SUBJECT: Addendum No. 2  
Hiwassee Utility Commission, Charleston, TN  
Water Treatment Plant Filters 1 – 4 Rehabilitation and Improvements

**ADDENDUM NO. 2**

**CONTRACT DOCUMENTS, SPECIFICATIONS, AND DRAWINGS  
FOR THE  
WATER TREATMENT PLANT  
FILTERS 1 – 4 REHABILITATION AND IMPROVEMENTS**

**HIWASSEE UTILITIES COMMISSION**  
**WATER TREATMENT PLANT**  
**FILTERS 1-4 REHABILITATION AND IMPROVEMENTS**  
**WALKWAY PLATFORM AND GUARDRAIL REPLACEMENT**  
**SHEET 1 OF 2**

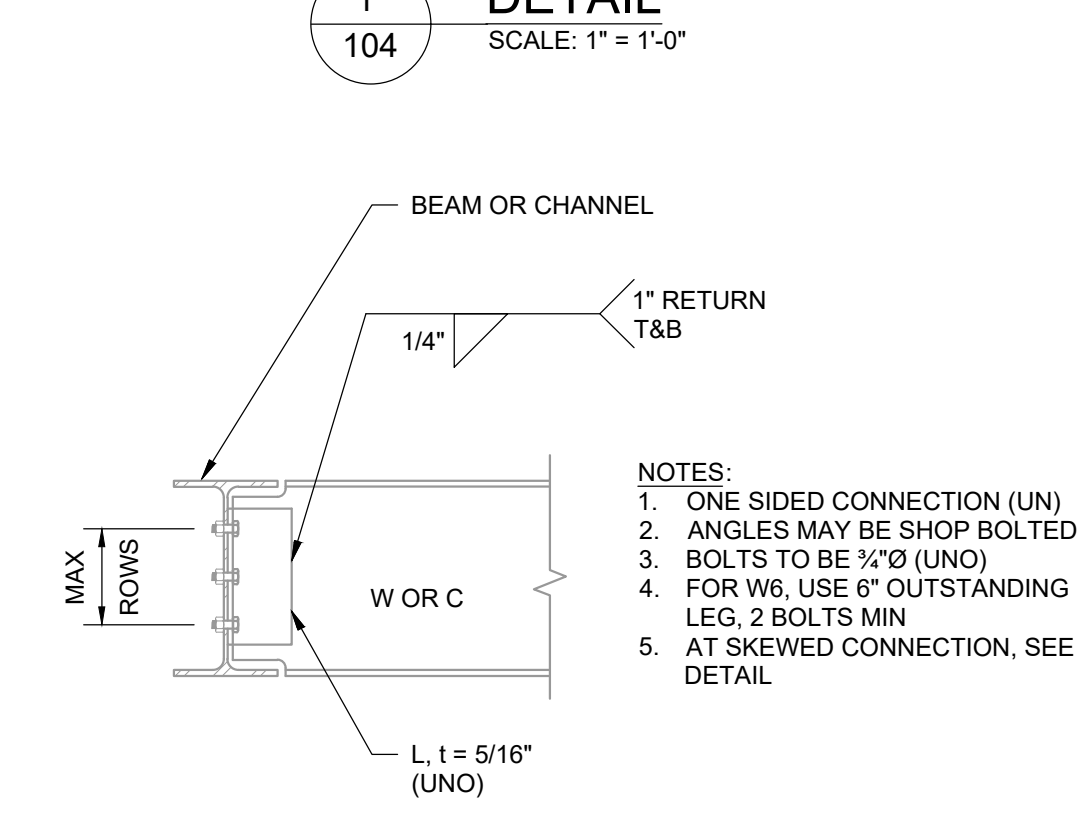
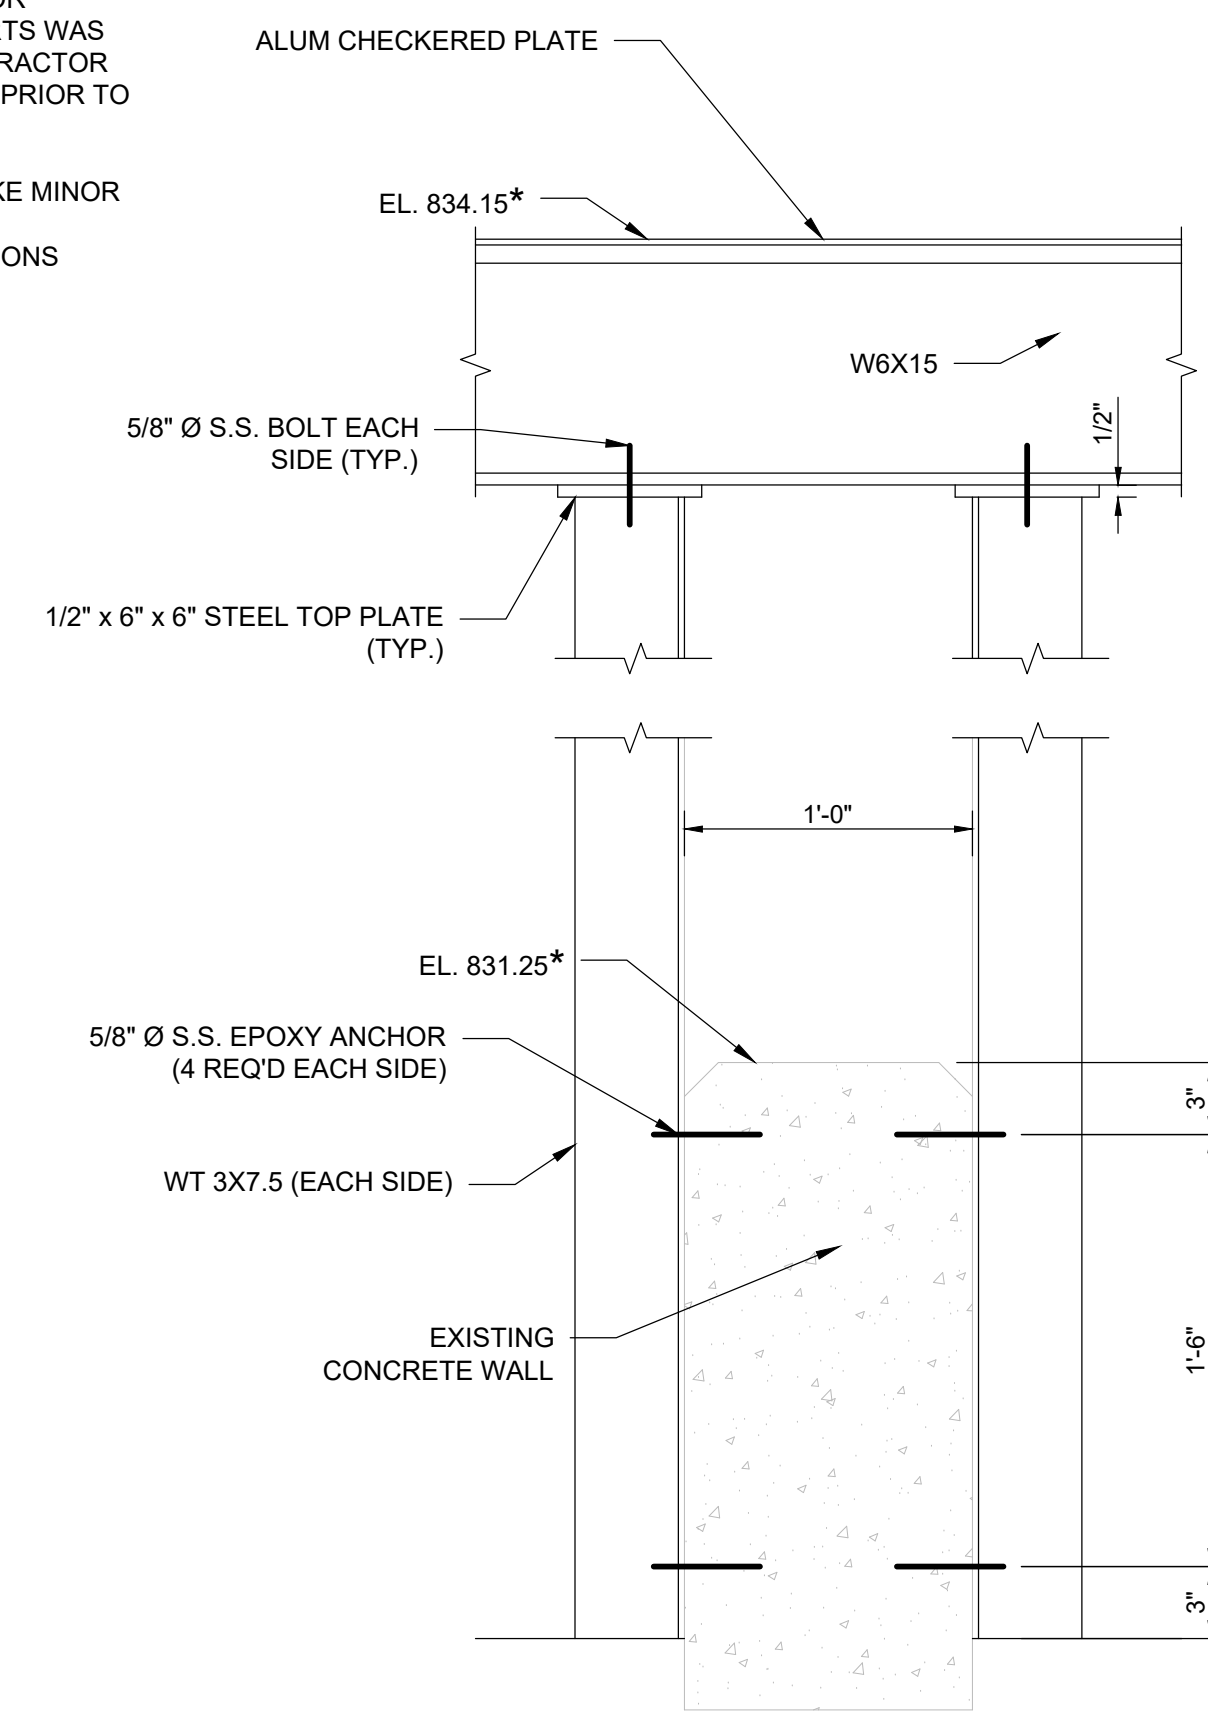
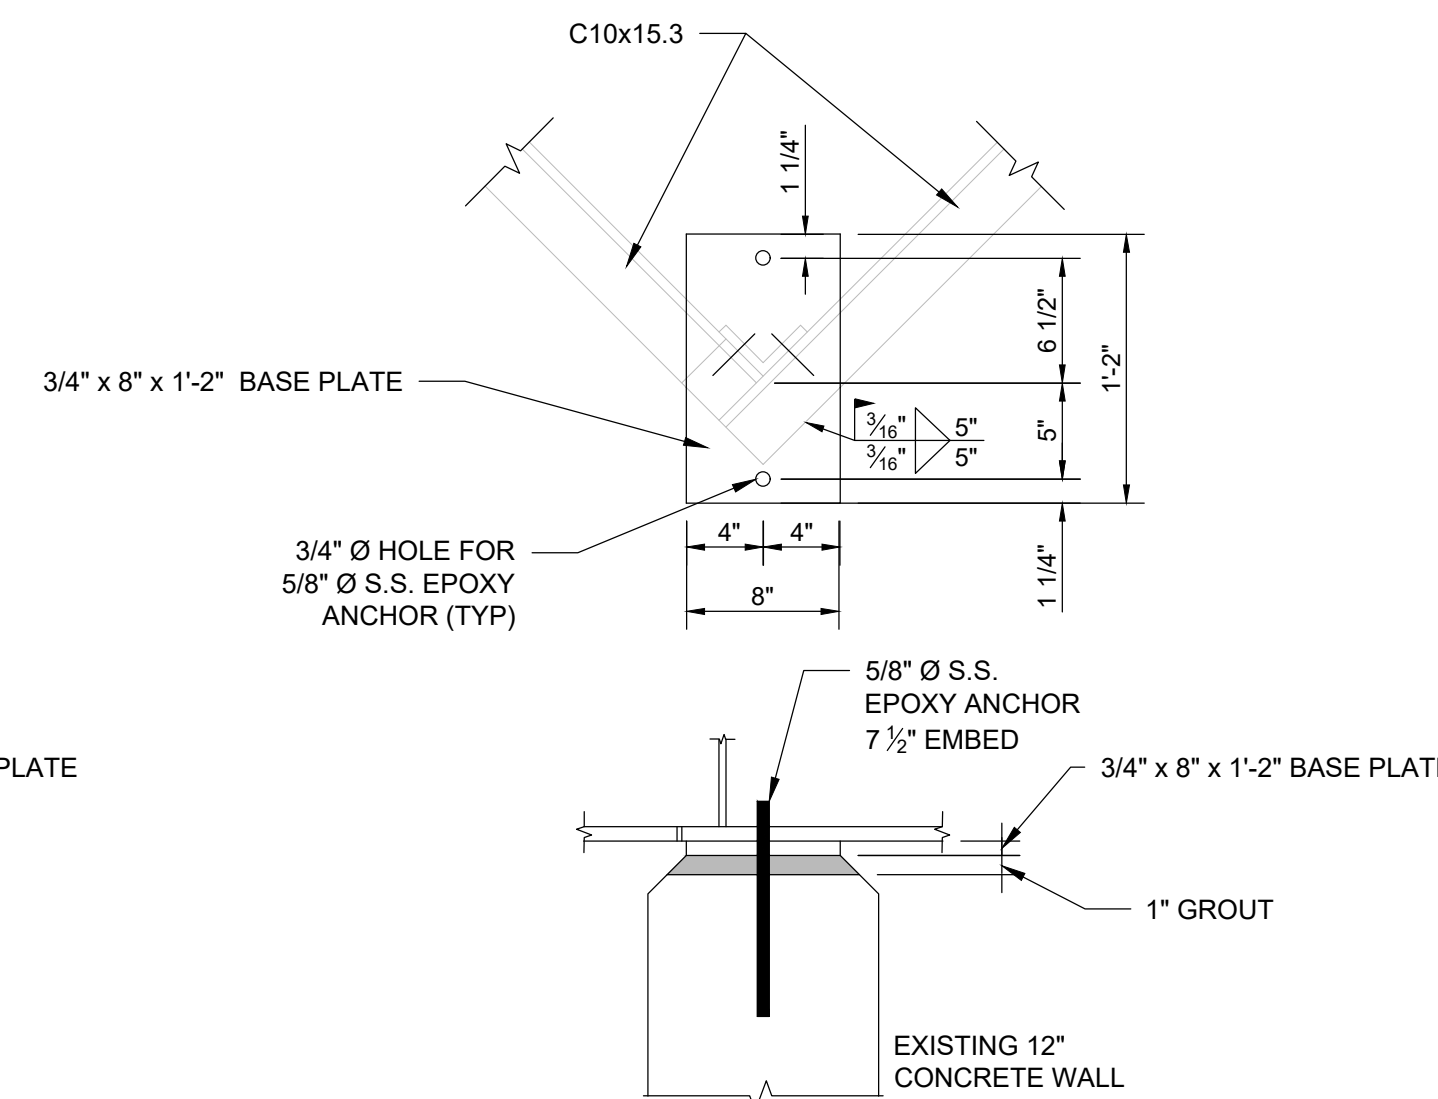
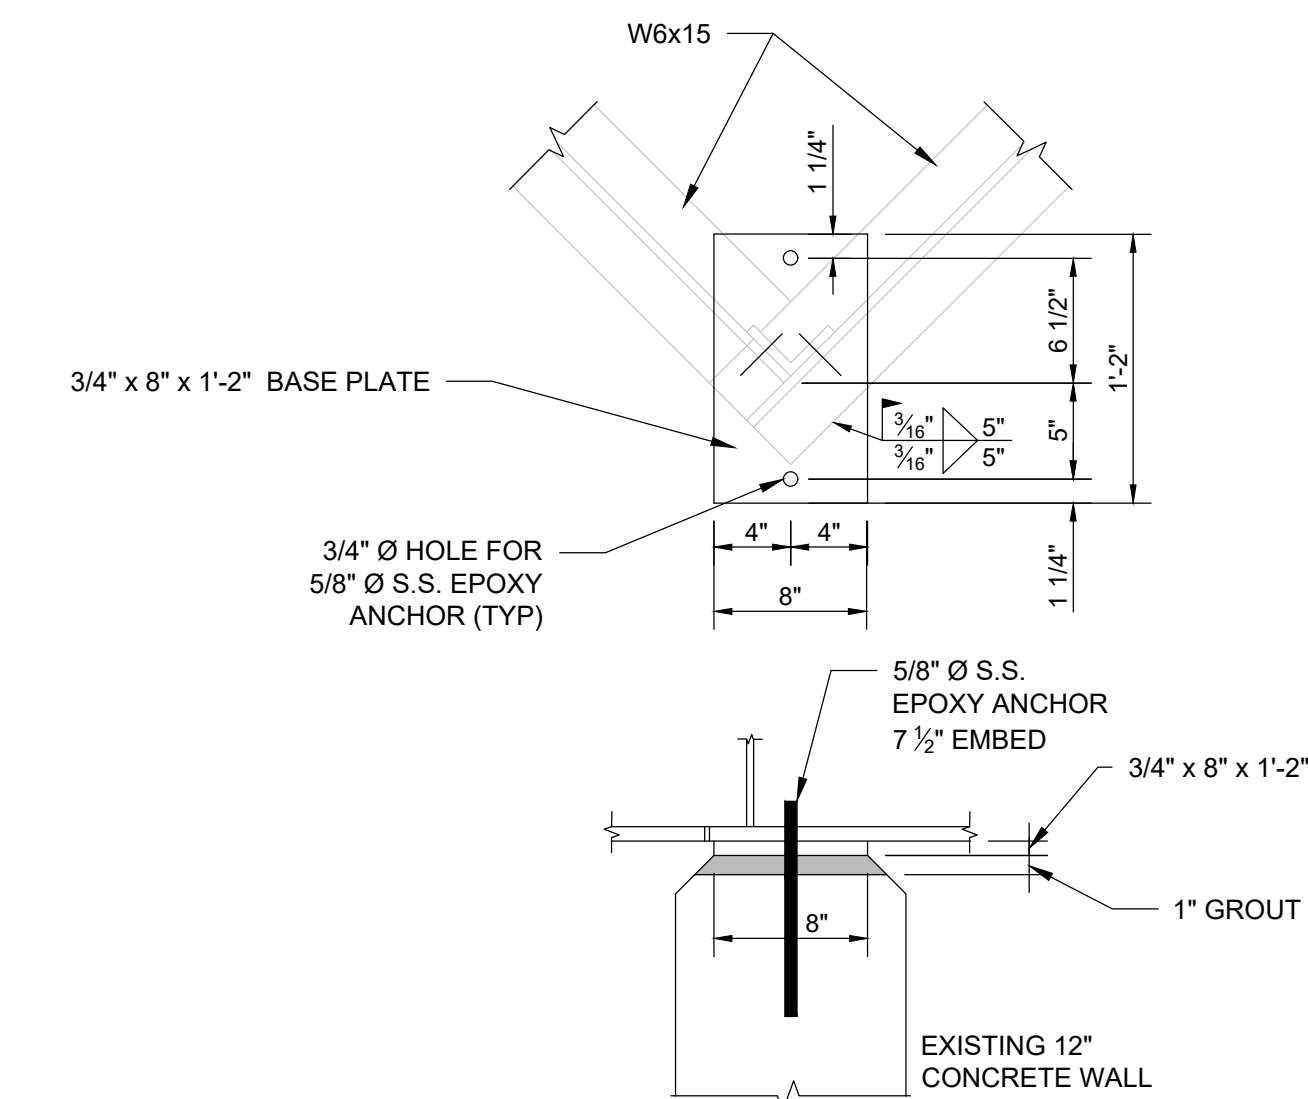
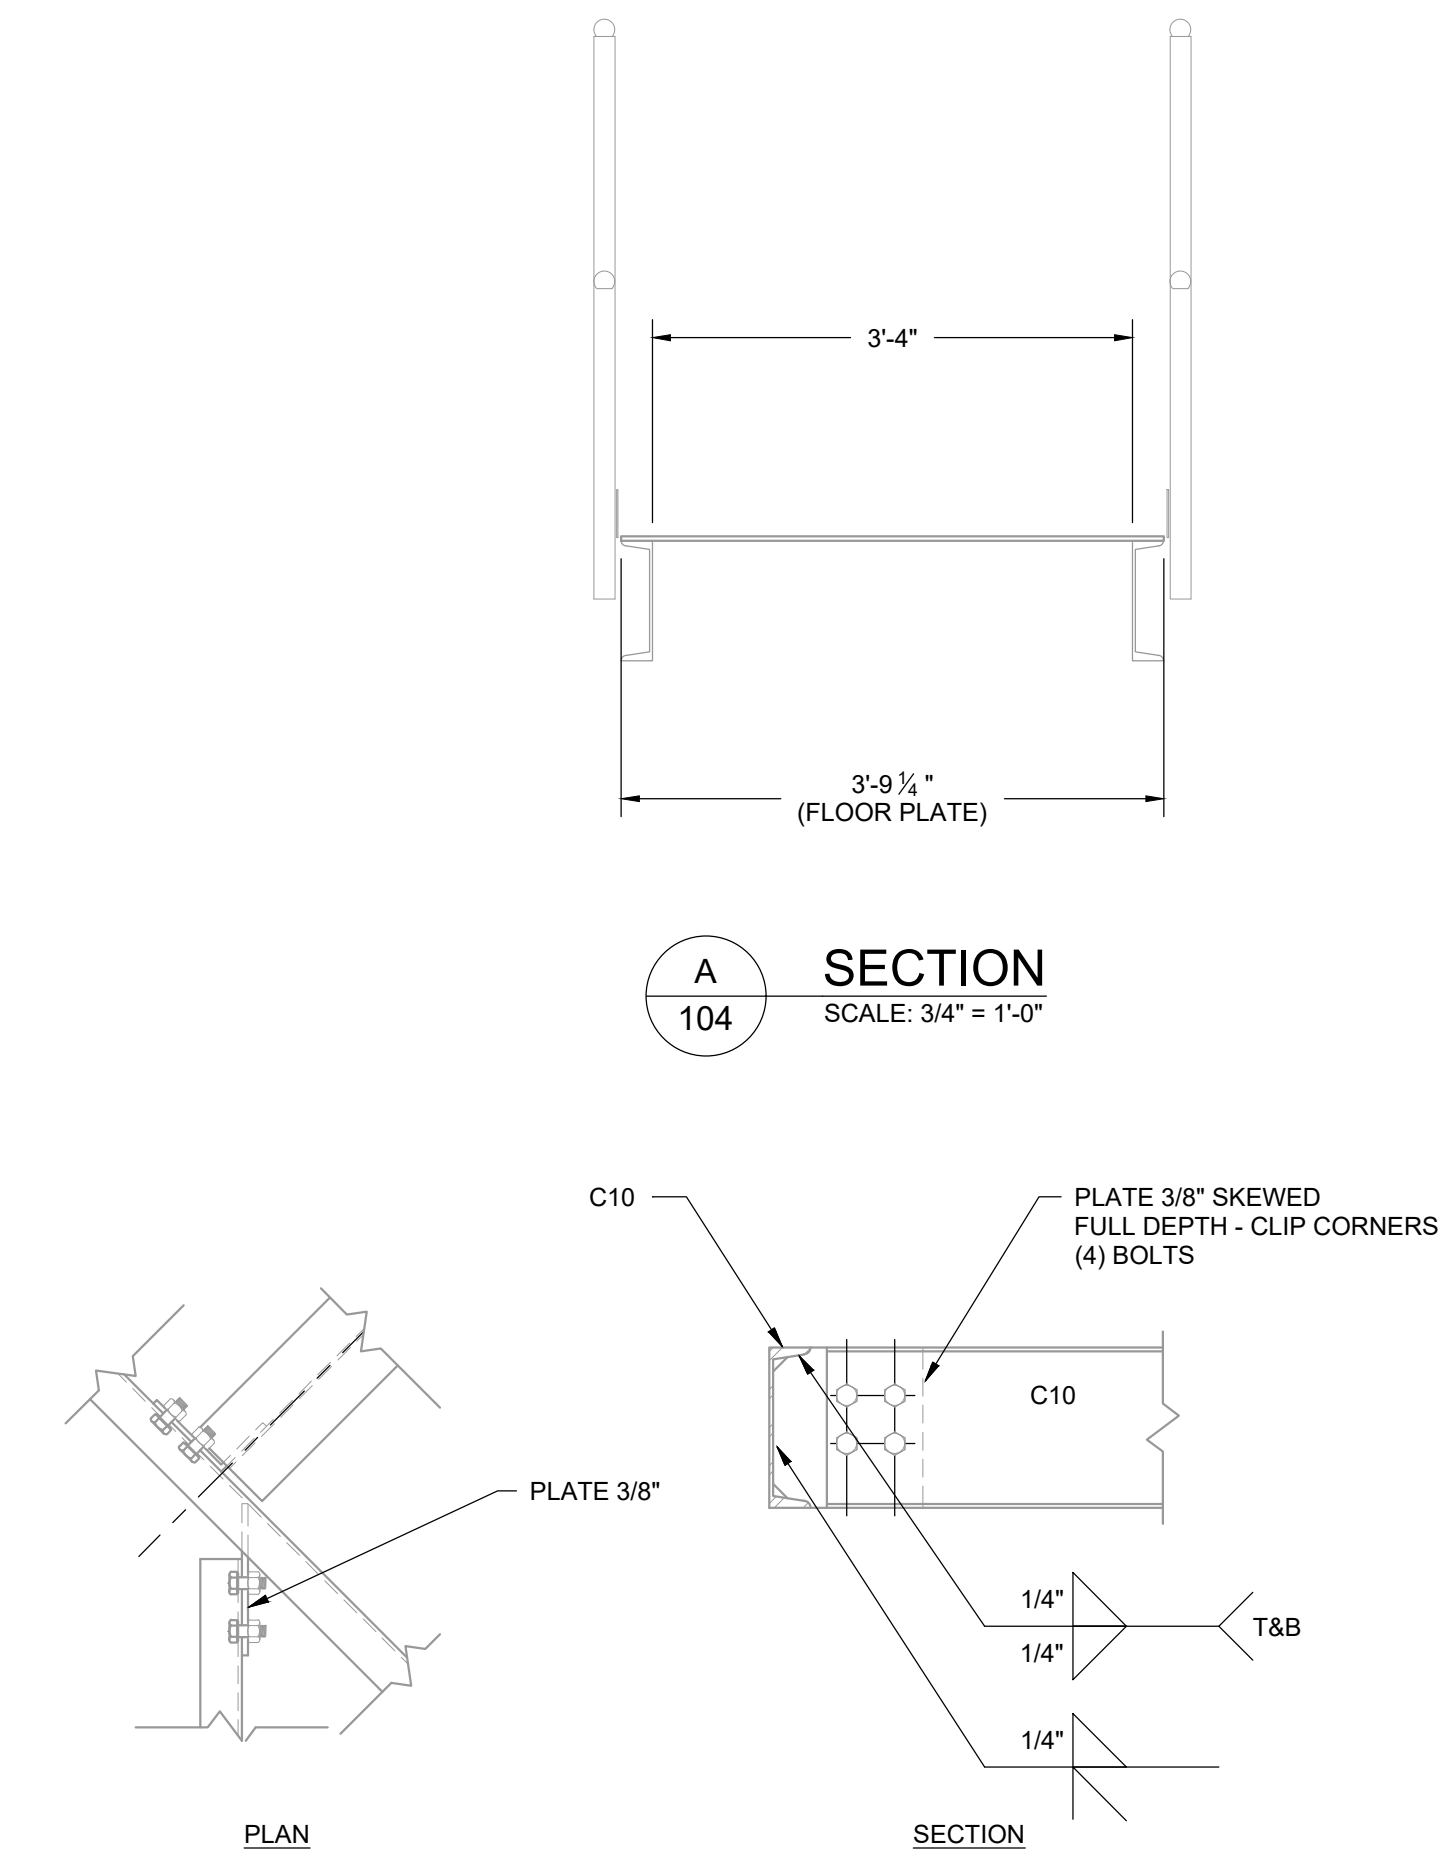
REVISIONS		DATE		BY		APPD	
NO.	DESCRIPTIONS	DATE	BY	PKG	KIL	PKG	KIL
1	CHANGED WALKWAY SYSTEM	5/30/23
